Comment i-251 and i-252

Reflections on darshan_13_0917 proposed fixes for i-251 and i-252

Corrected fixes for i-251 and i-252

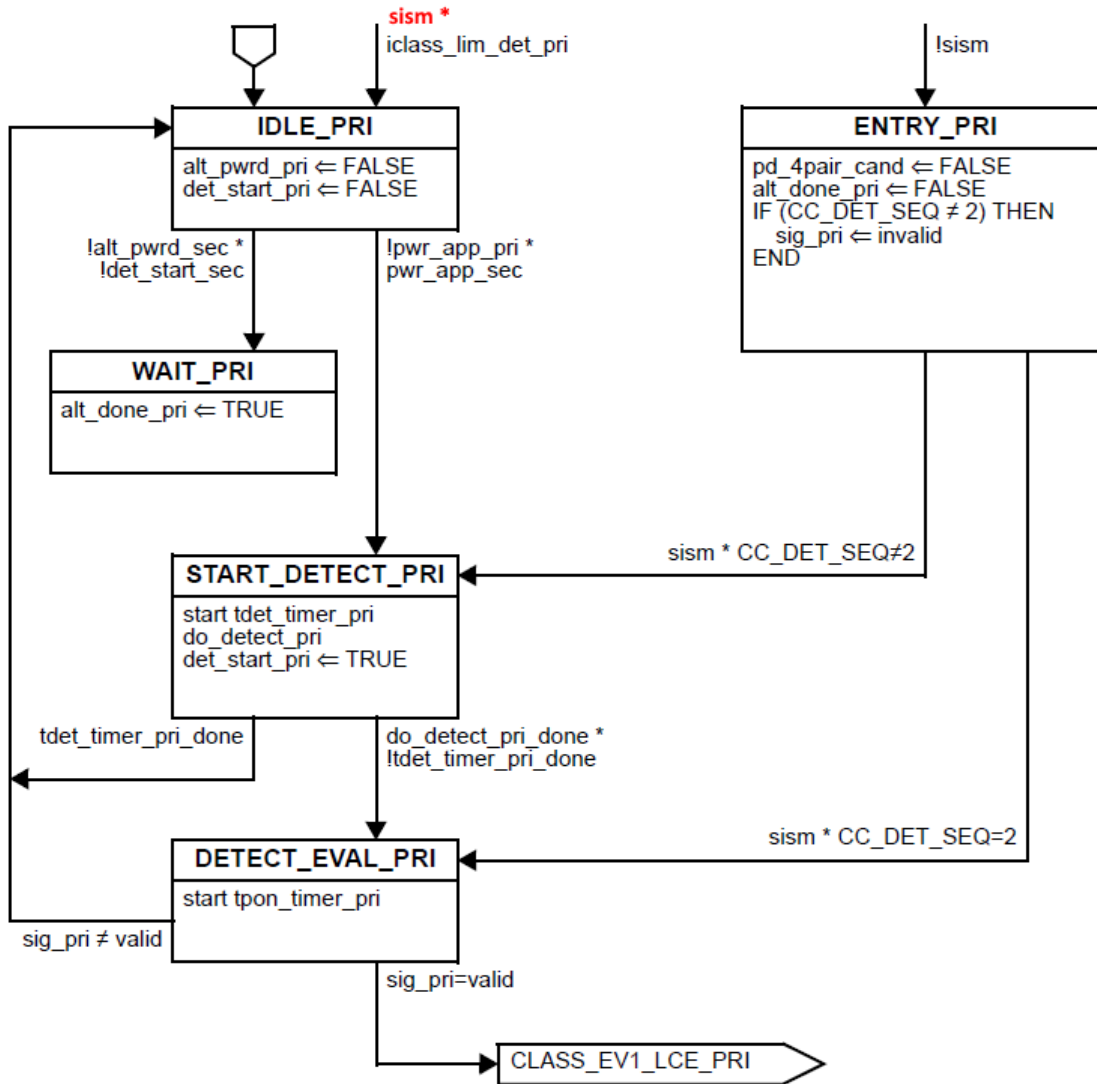
darshan_13_0917 creates the opportunity for a failed detection on the primary pairset to be followed by a successful detection and power-on on the secondary pairset. This will allow Tpon violations. Tpon violations may occur as do_detect_pri, even if invalid, can take up to 500ms, during which time the object connected to PSE PI may change.

The entire logic behind moving to an explicit description of the CC/DETECT sequences was to make impossible a PD removal-reinsertion during the entire CC-DETECT-CLASS-POWER sequences 0, 1, 2 and 3 for both single and dual signature PDs. Instead of allowing the secondary to power on after the primary has failed (and is in WAIT_PRI) we must instead require a new Connection Check.

Modify Figure 145-15 to add sism term IDLE_PRI entry

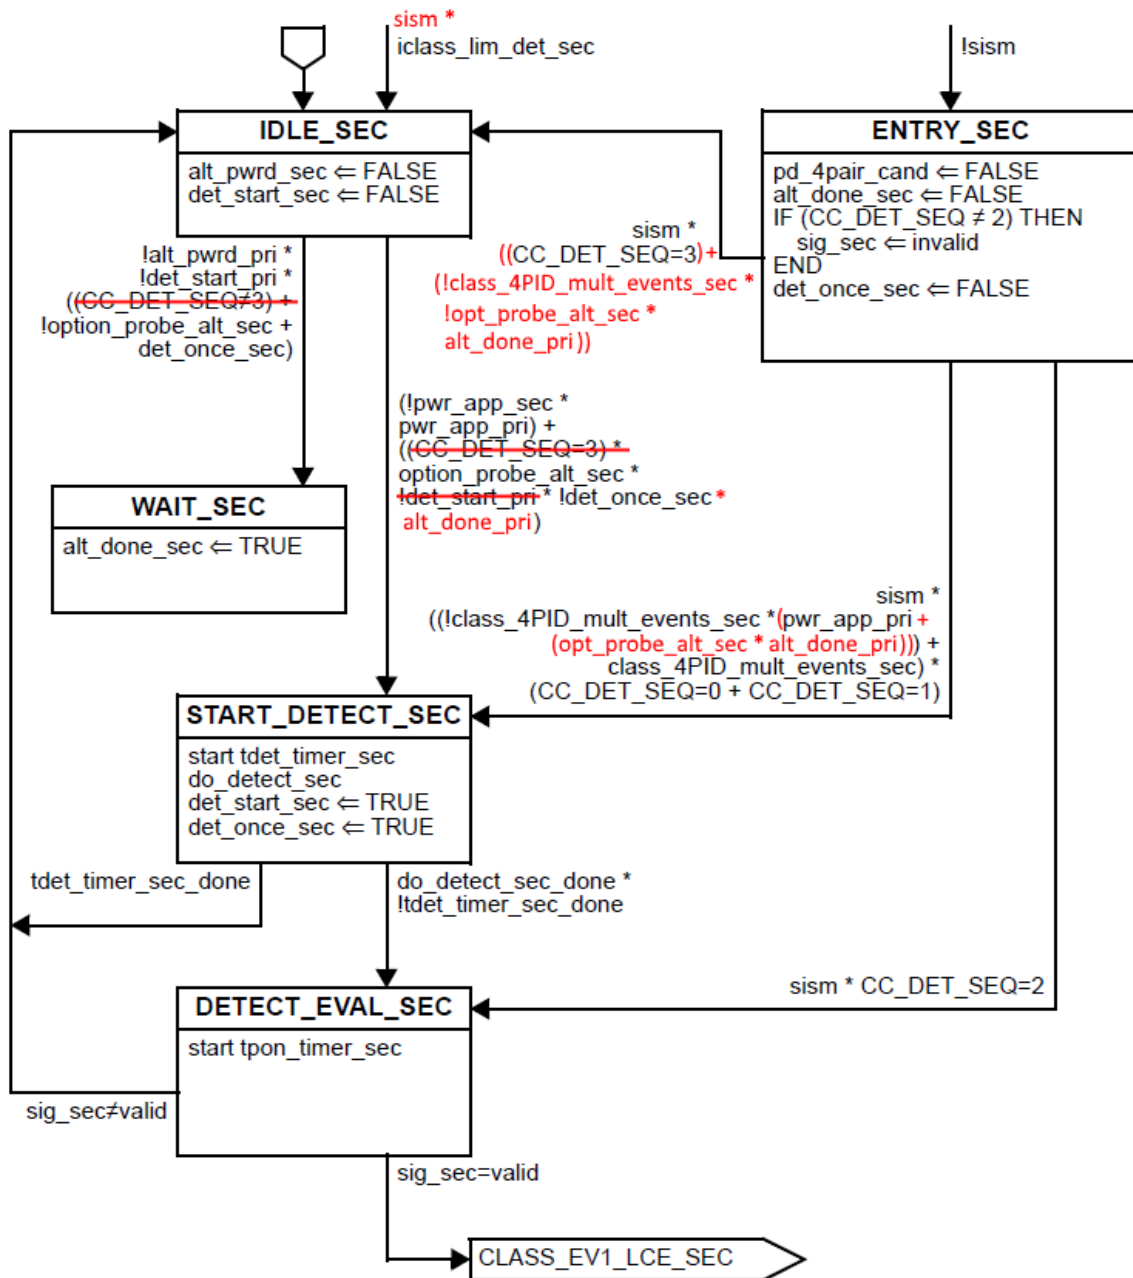
Comment i-251 (Page 136 Line 20).

In the exit from ENTRY_SEC to START_DETECT_SEC, when selecting CC_DET_SEQ 0 or 1, and class_4PID_multi_event_sec = FALSE, the secondary state machine allows to move from ENTRY_SEC state to START_DETECT_SEC only if pwr_app_pri = TRUE per the existing condition:

If Primary fails to powerup, the Primary state machine returns back to IDLE_PRI. As a result, pwr_app_pri variable will remain in FALSE, and the secondary state machine won't be able to exit from ENTRY_SEC i.e. will be stuck there.

Comment i-252 (Page 136 Line 21).

When class_4PID_multi_events_sec=FALSE, and CC_DET_SEQ=0 is TRUE or CC_DET_SEQ=1 is TRUE, If START_DET_PRI exit to IDLE_PRI due to tdet_timer_pri_done, the pwr_app_pri will remain in FALSE which won't allow exiting from ENTRY_SEC to START_DETECT_SEC and the secondary state machine remain stuck in ENTRY_SEC.

Note: Even if we did detection before tdet_timer_pri is expired, we will get tdet_timer_pri_done anyway at some time. There is missing stop timer assignment.

The following proposal ensures that detect/class cycles on the secondary pairset (when primary pairset is not powered) are always for inspection purposes only and will not allow power on from the secondary pairset – thus preserving Tpon. In addition comments i-251 and i-252 are addressed. Further, the implementation of option_probe_alt_sec is (incidentally) corrected so an “inspection-only” detect/class on the secondary side does not apply power per the agreed behavior in stover_01_1116_rev01.pdf.

Modify Figure 145-16 to allow return to

- add sism term IDLE_PRI entry
- Allow SEQ0/1 to exit ENTRY_SEC to IDLE_SEC if staggered detect fails on primary for any reason (!valid or tdet_timer_done)
- Fix SEQ3 IDLE_SEC to START_DETECT_SEC to move uniformly to START_DETECT_SEC
 - o Was moving after class in one case and after powerup in the other
- Grant option_probe_alt_sec behavior to SEQ0/1 in ENTRY_SEC to START_DETECT_SEC arc

Modify Figure 145-16 to

- Properly terminate an "inspection only" option_probe_alt_sec.
 - o This implies staggered detects cannot power secondary if primary detect result is invalid
 - o Also preserves tpon
